STATEMENT OF RESPONSE TO AN BORD PLEANÁLA'S CONSULTATION OPINION

**IN RESPECT OF A
PROPOSED RESIDENTIAL DEVELOPMENT
AT FARRANKELLY, DELGANY, GREYSTONES, CO.
WICKLOW**

Client:	Cairn Homes Properties Ltd.
Project Title:	Farrankelly SHD
Document Title:	Statement of Response to An Bord Pleanála’s Consultation Opinion
Document No:	17010SRABPF01

Figure 2.1 – Revised Priory Road Arrangement - Plan

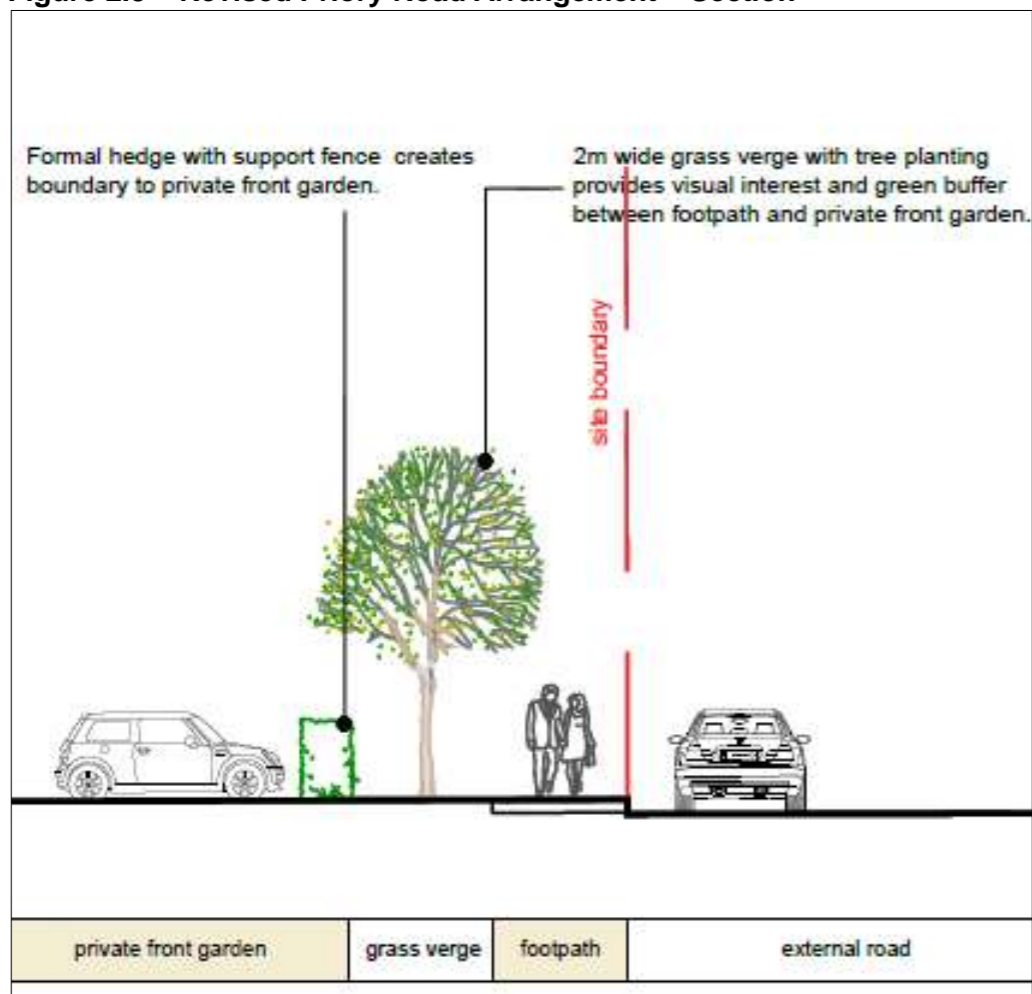
“Further consideration/amendment of the documentation as they relate to the frontage along Priory Road, having regard to the change in the character and function of that road from a rural lane to a street within the urban area that is envisaged in the local area plan.”

2.7 Review of the frontage along Priory Road through the omission of the shared local street, (located behind Priory Road) and its replacement with 3 no. direct access points to serve the 9 no. dwellings, reconfiguration of the southern element of the site adjoining Priory Road and Eden Gate, (through the omission of unit no. 106 as previously proposed in the pre-application submission).

2.8 The two storey dwellings located at the southern end respond to the levels of the site which drop at this location and is considered more appropriate than a continuation of the dormer arrangement to the north of the link street.

2.9 The design intent is to provide an appropriate transition in form and character along Priory Road whereby dormer typologies are provided, including an urban edge, which overlooked by residential accommodation with some planting responding to the existing condition.

Figure 2.5 – Extract from Topographical Layout showing levels

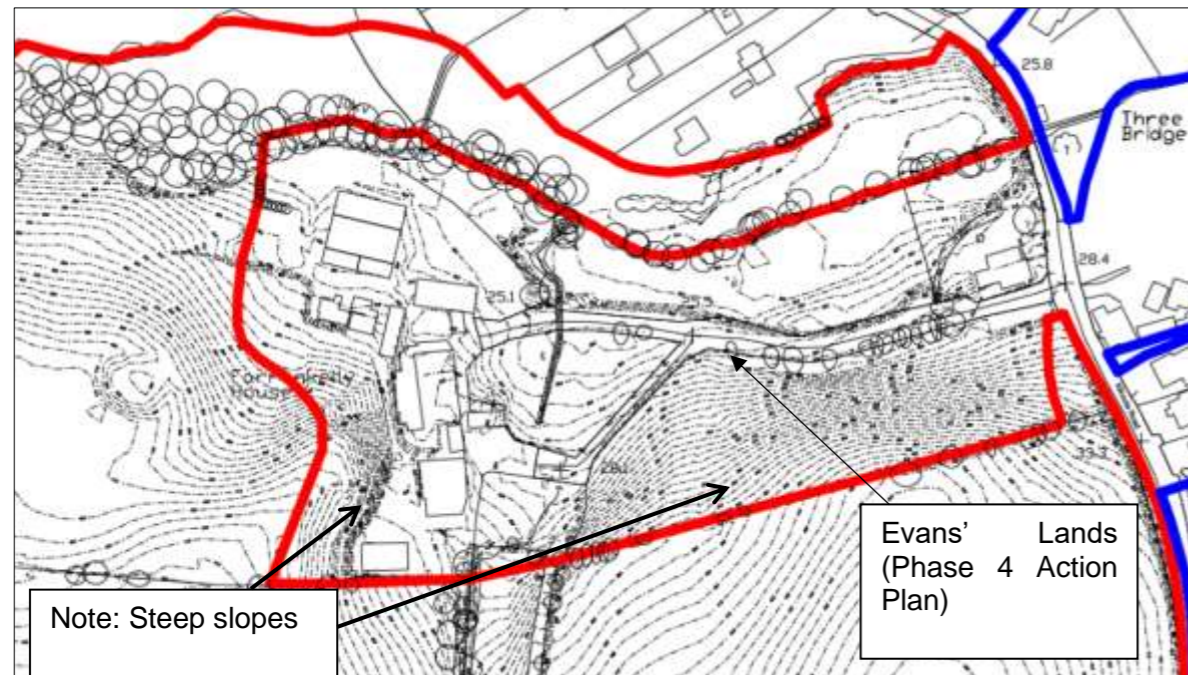
“Further consideration of the documentation as it relates to the levels across the site and its impact on co-ordinating development with the remainder of the lands under the AAP6 zone that are outside the site, and on the treatment and use of private and public open space across the scheme development.”

2.15 Along the internal link road, a pedestrian connection could be provided. The levels within the site and adjoining the adjacent lands within the future separate phase of development (as per Action

Figure 2.17 – Revised Duplex Arrangement

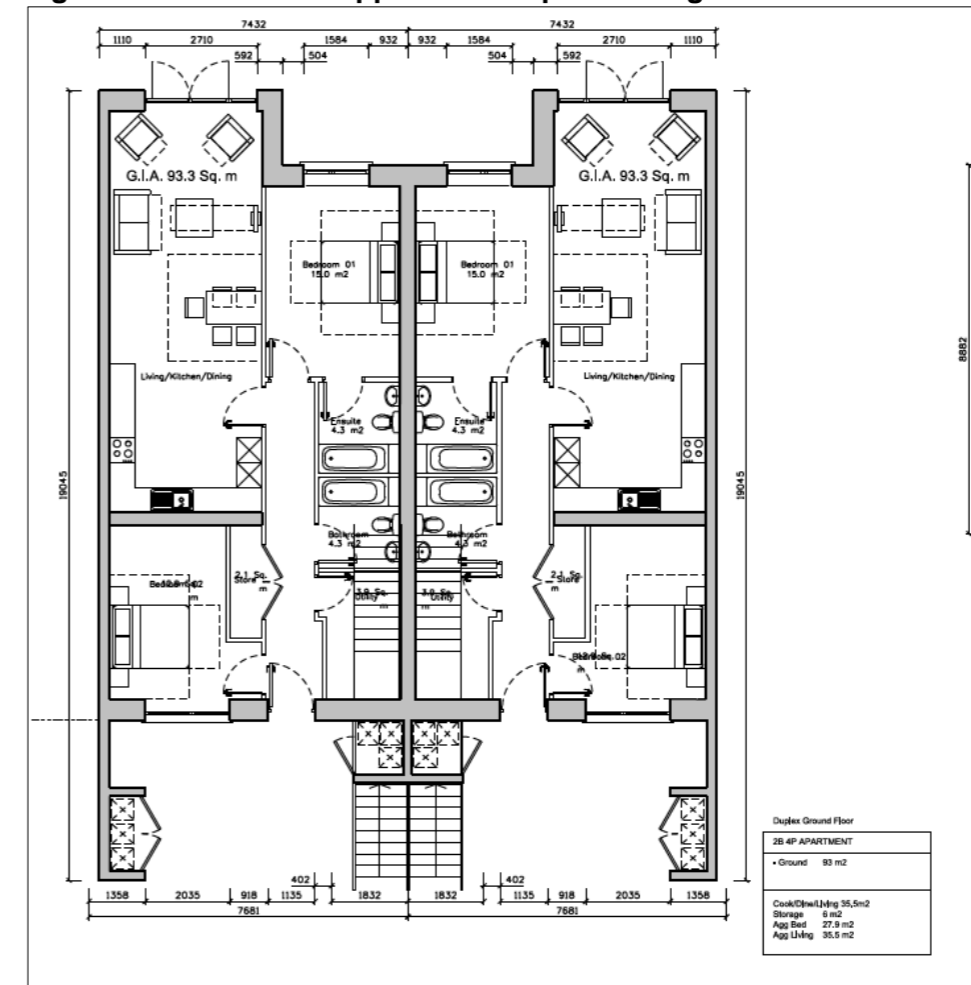
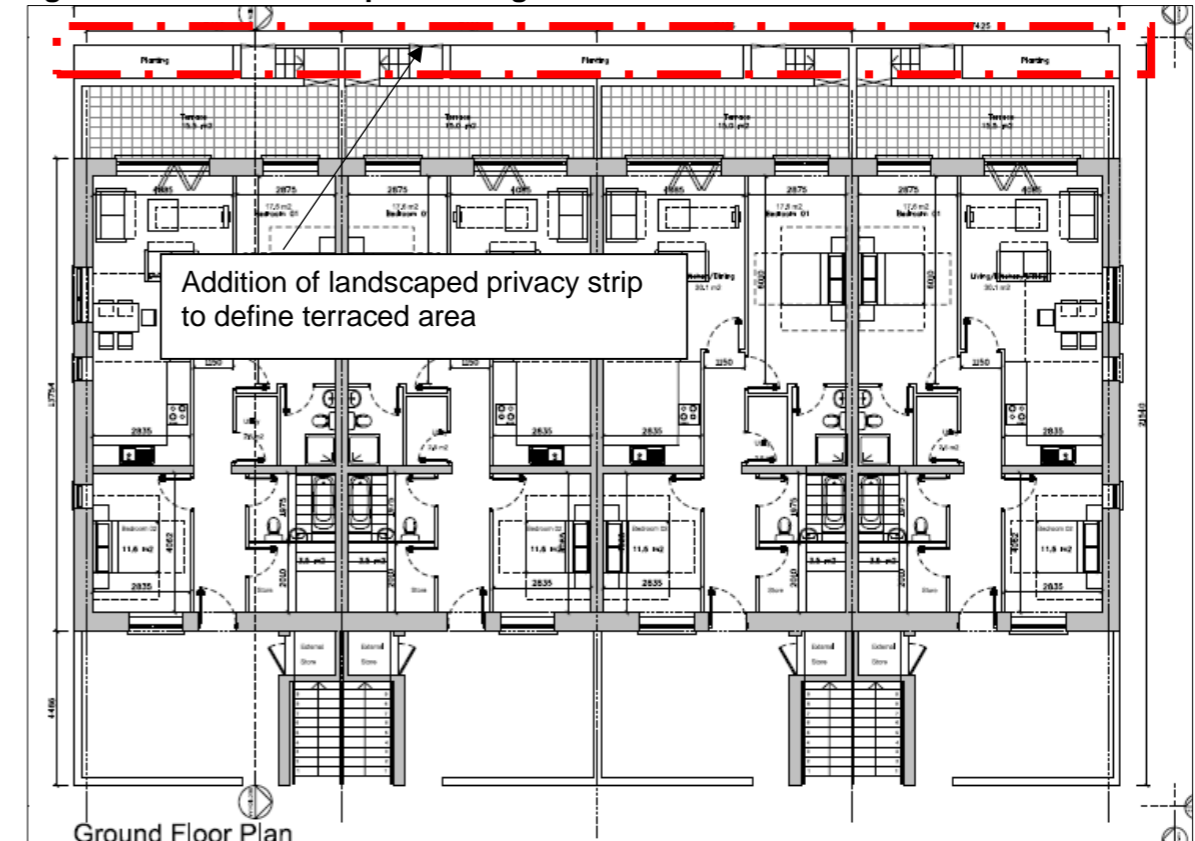
2.41 In response to this item, the configuration of the proposed duplex units has been amended to provide a more defined relationship between the building curtilage and the adjoining lands. It is noted an issue raised by the Board, as discussed at the pre-application consultation meeting with An Bord Pleanála and Wicklow County Council was that there could be more delineation provided for between the ground floor amenity space of the duplex unit and the wider areas.

2.43 The new arrangement is shown below which now shows a delineated terraced area at ground floor level, which also includes a planted area to provide additional privacy, offering a higher degree of residential amenity compared to the arrangement proposed at ABP pre-application stage.

2.48 3 no. Duplex Block Type B units are proposed along local street 13. The stepped entrance to Duplex block B address local street 11 while the first floor terrace is on the south side overlooking the open space and avails of the south views and orientation. Overall, the proposed duplex units will provide a high degree of residential amenity and will be situated in a high-quality urban setting with integrated landscaping throughout.

Figure 3.11 – Western Boundary - Section

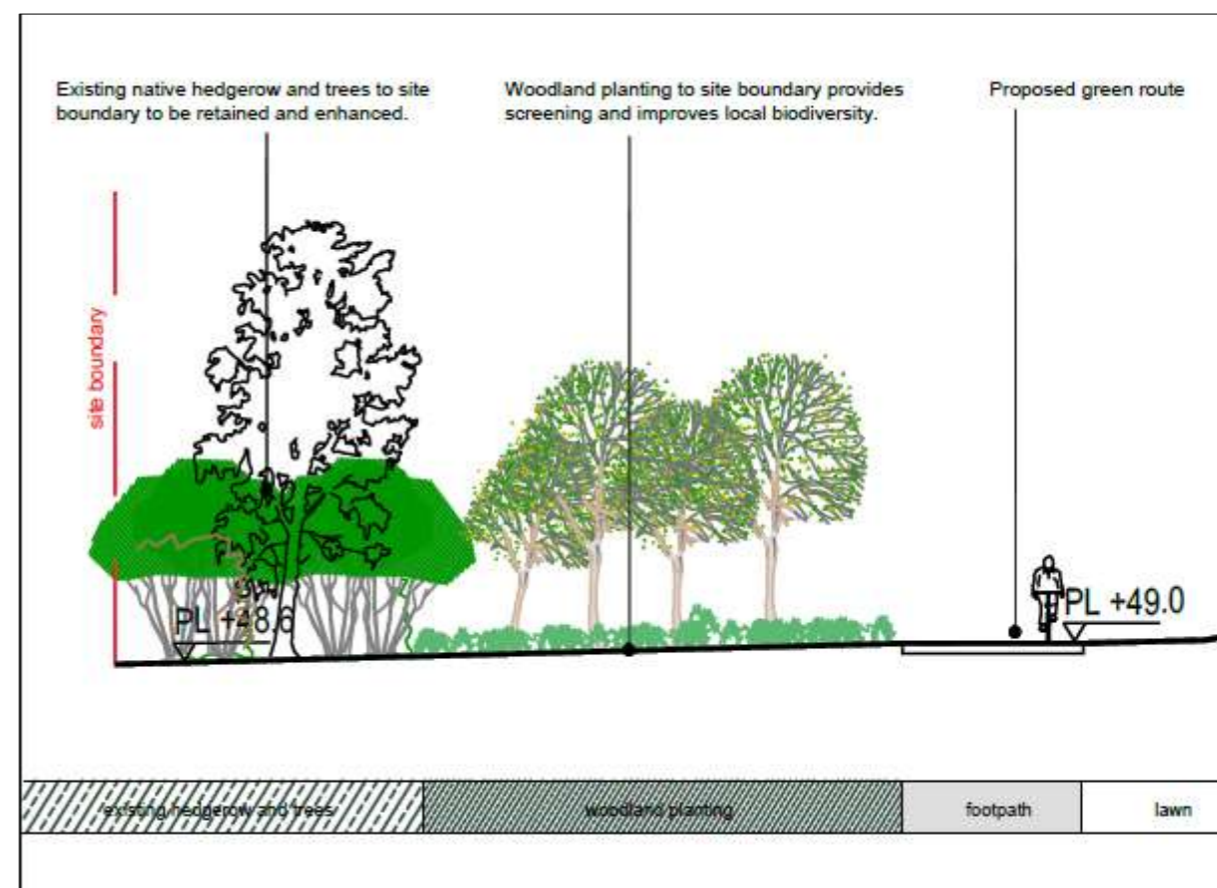
“Details of proposed boundary and surface treatments throughout the development, and of landscaping and planting. Proposals should also be submitted to ensure ongoing public access to the facilities on the active open space that could be incorporated into an agreement with the planning authority or a condition attached to a planning permission.”

3.7 With reference to the western boundary, the existing native hedgerow and trees to the subject lands will be retained and enhanced, with additional woodland planting.
